Number	FF.1
Section	Automatic Transmission
Sheet	1 (of 1)
Date	May, 1960

TORQUE CONVERTER SETSCREWS

(All Automatic Transmission Models)

FIG 1

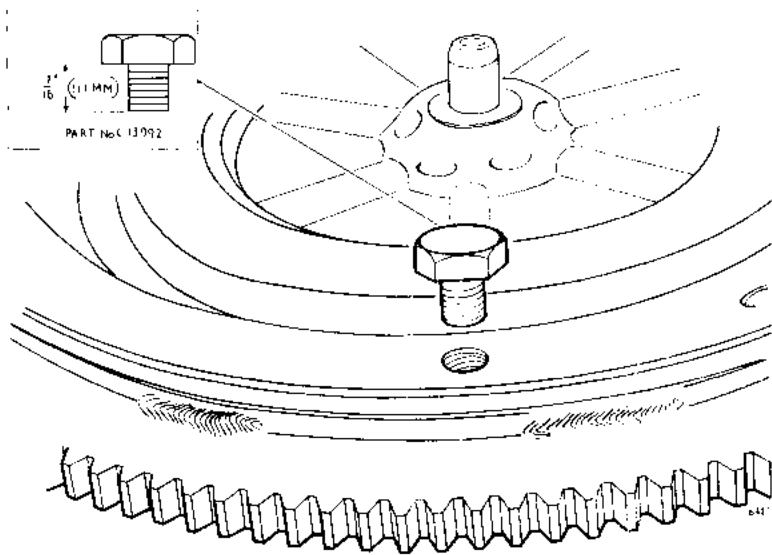
Note that it is ABSOLUTELY ESSENTIAL that the long setscrews which are $17/32''$ (13.5 mm) in length (see inset in Fig.2.) are not fitted to a torque converter which does not have cut-a-ways machined under the setscrew holes, otherwise the setscrews will bottom in the holes. A torque converter without the cut-a-way is illustrated in Fig.1; the $7/16''$ (11.1 mm) long setscrew which MUST be fitted to this type of converter is shown inset.

FIG 2

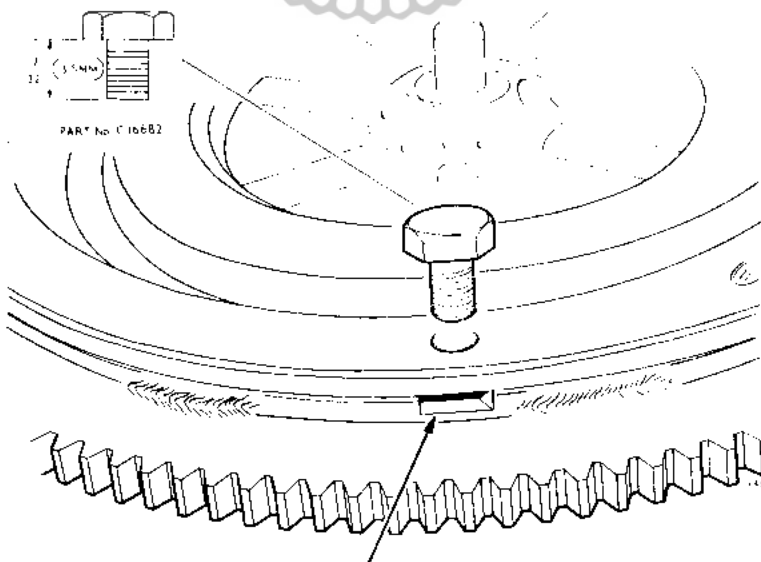
Torque converters are now secured to the drive plate with longer setscrews (Part number C.16682). To ensure full engagement of the longer thread, a cut-a-way is machined in the torque converter below each threaded hole as indicated by the arrow in Fig.2.

FIG 1

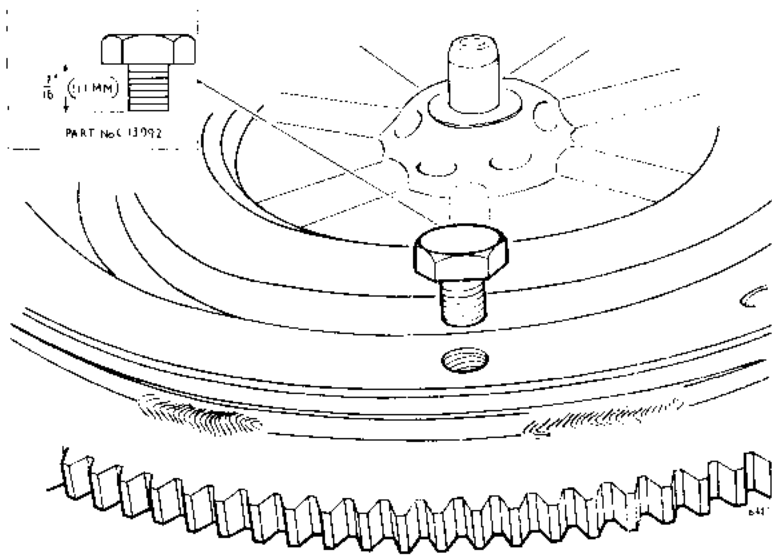
Note that it is ABSOLUTELY ESSENTIAL that the long setscrews which are $17/32''$ (13.5 mm) in length (see inset in Fig.2.) are not fitted to a torque converter which does not have cut-a-ways machined under the setscrew holes, otherwise the setscrews will bottom in the holes. A torque converter without the cut-a-way is illustrated in Fig.1; the $7/16''$ (11.1 mm) long setscrew which MUST be fitted to this type of converter is shown inset.

FIG 2

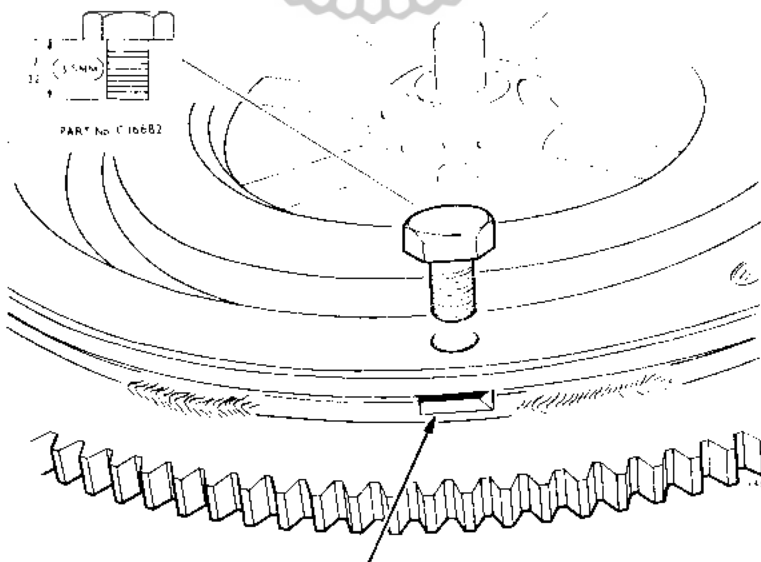
Torque converters are now secured to the drive plate with longer setscrews (Part number C.16682). To ensure full engagement of the longer thread, a cut-a-way is machined in the torque converter below each threaded hole as indicated by the arrow in Fig.2.
